To	BallardAve@seattle.gov ,
Cc	amy.enbysk@seattle.gov , Dan.Strauss@seattle.gov , brymason@msn.com , derek.m.herman@gmail.com , corey@coreyford.name , clara@seattlegreenways.org ,
Bcc	
Subject	Ballard Ave Mobility Improvements Feedback

I'm writing on behalf of [Ballard-Fremont Greenways](#) to provide feedback on the [Ballard Ave Mobility and Access Improvements](#).

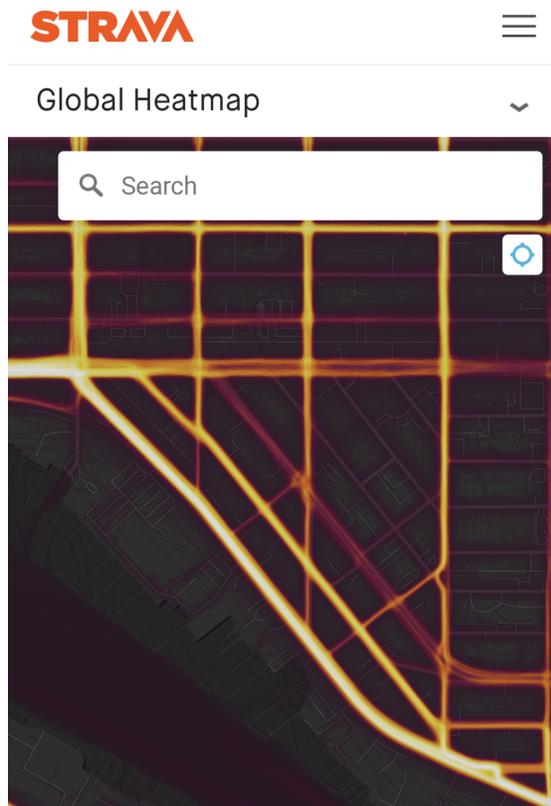
We are concerned, however, that the formalization of one way NW bound traffic on Ballard Ave between 20th Ave NW and 22nd Ave NW is overlooking the needs of two demographics - 1) people who bike and 2) people who use mobility devices.

We start by looking into 1) first: Cyclists often ride SE along Ballard Ave to **access** businesses along this segment and as an **alternative** to the auto-heavy NW Leary Way and Shilshole Ave NW.

See the images below which show that Ballard Ave is a popular street for bikes:

We recommend that SDOT install a [contraflow bike lane](#) going SE along Ballard Ave. One way to do this would be to merge the loading zones with the parking and loading zones. This would free up the space needed for a contraflow bike lane along the Shilshole side of Ballard Ave while maintaining loading capacity.

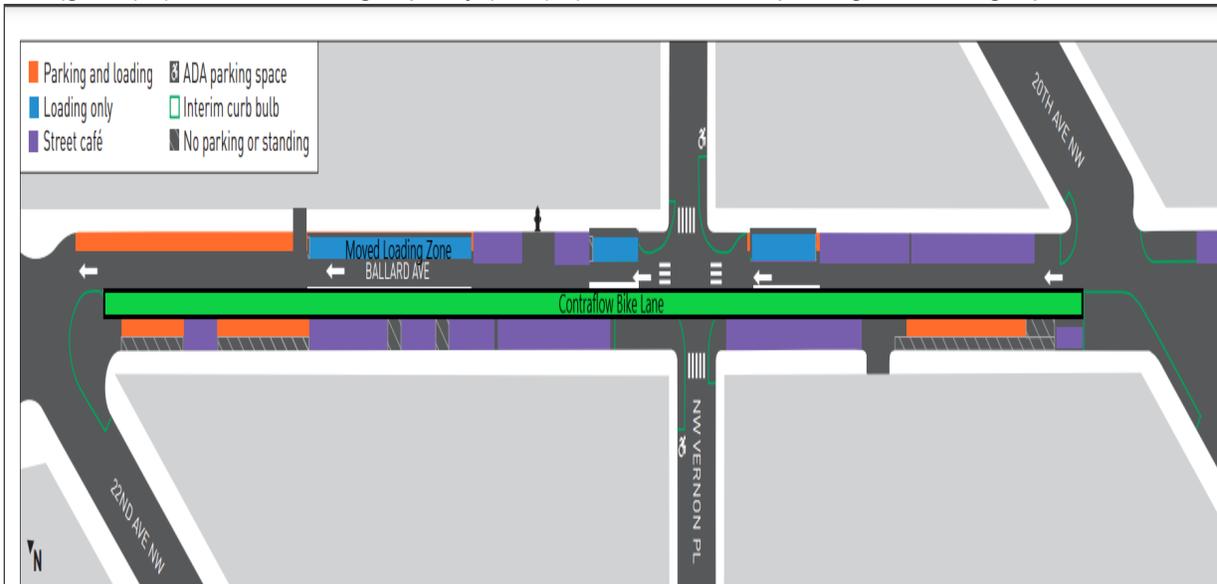
However, the current plans for Ballard Ave **overlook** people on bikes. Cycling is an *incredibly efficient* way of connecting **people** to businesses.

Here are two SUVs taking up the curb space of nearly **two whole storefronts**:
